FIELD SERVICE BULLETIN

Subject: Purge timer change

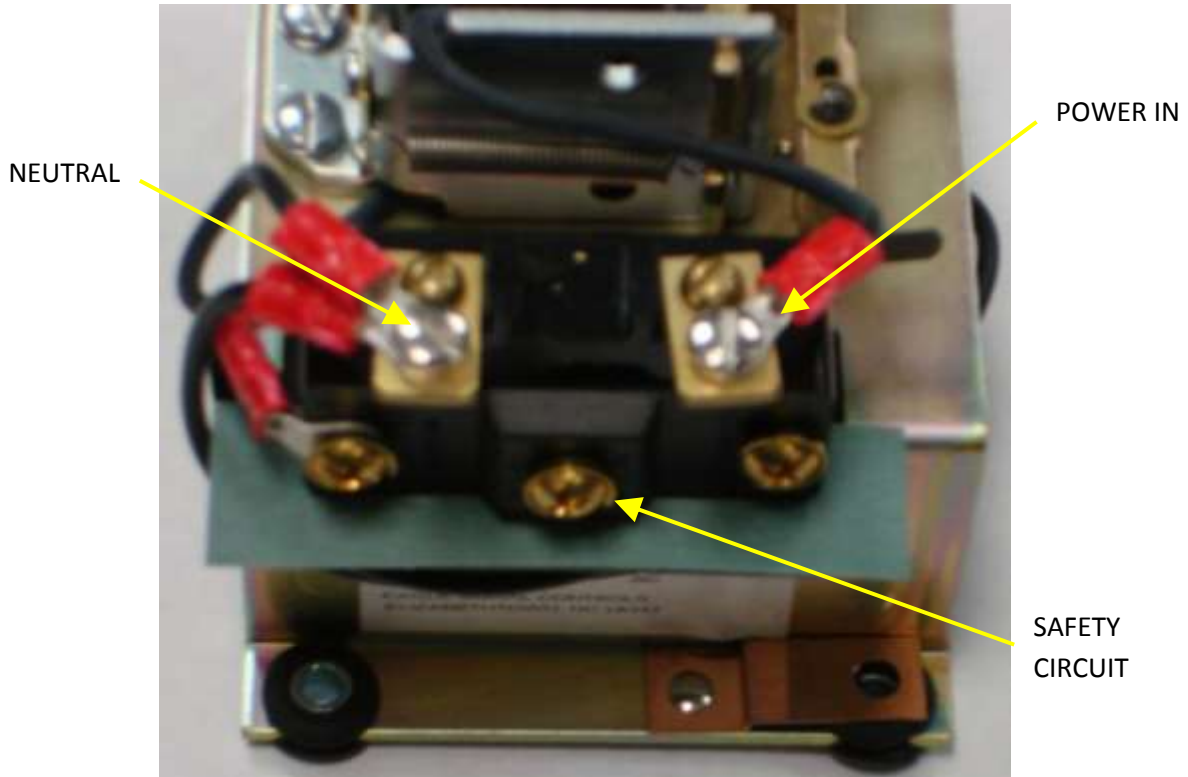
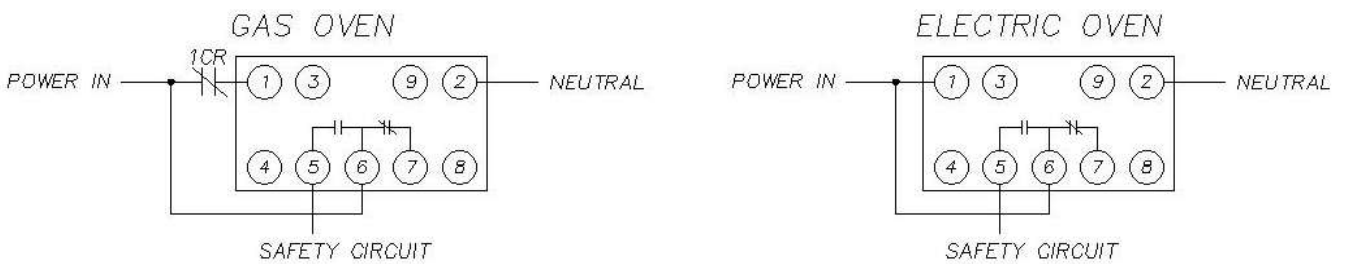
Our standard purge timer part number 012425 has become obsolete, and is being replaced by part number 253100. See page 2 of the bulletin for wiring changes.

Note: Add jumper between terminal 1 and 6 for electric ovens.
